UNITED STATES PATENT AND TRADEMARK OFFICE

Office Action Summary	Application No. 10/508,916	Applicant(s) MCCREARY ET AL.	
	Examiner TAMMY PHAM	Art Unit 2629

DETAILED ACTION

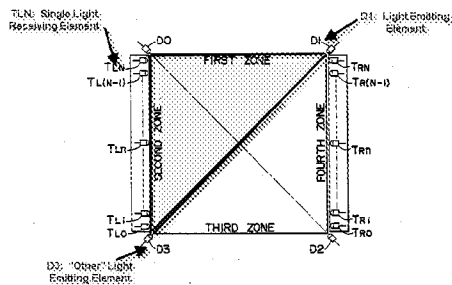
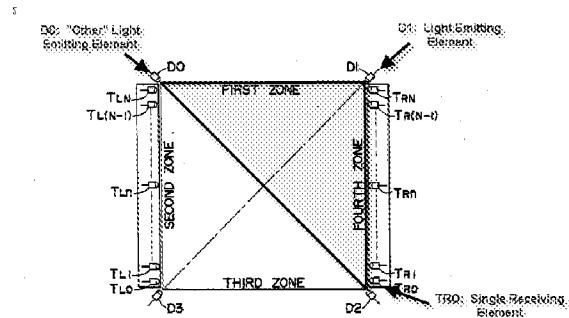
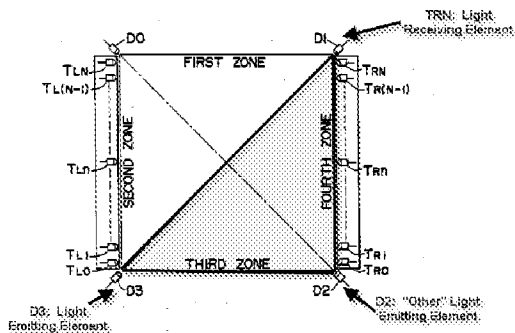
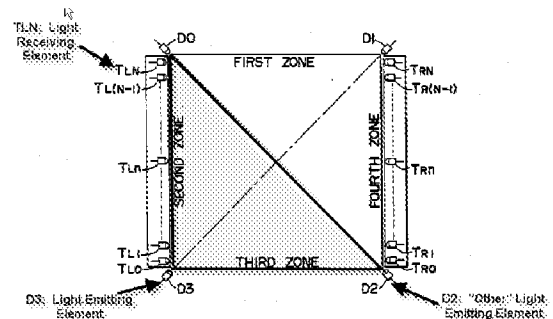
5. First, there is no support for this newly amended claim language. Second, even that there is support for it, the claim language remains broad. In particular, as explained in the previous office action of 21 August 2009, Sherbeck teaches of at least four zones (shown below in diagrams 1-4). The touch event (Diagram 5), is completely within at least two zone pairs (where the two zone pairs are shown at least in two examples which includes the zone pairs in Diagrams 1, 3; and the zone pairs in Diagrams 2, 4). Hence, Sherbeck continues to read upon the claim language as currently stated.

Diagram 5: Touch Event Completely Within at Least Two Zone Pairs

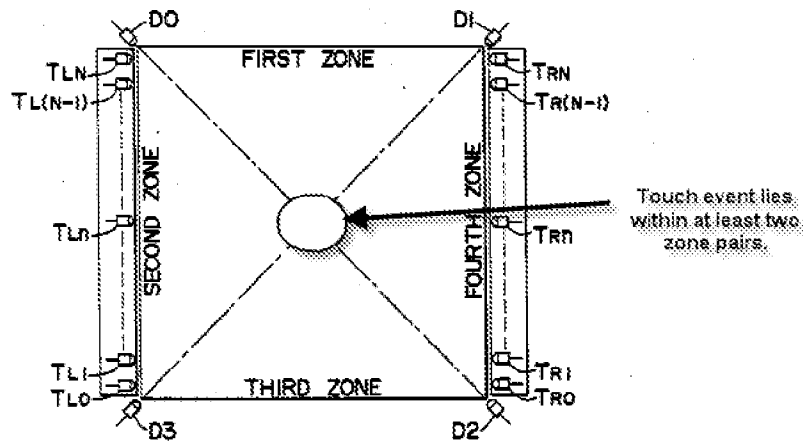
event lies completely within at least two zone pairs (for example, if the touch event was in the middle of the display of Figure 1, as shown above in Figure 5), the method comprising:
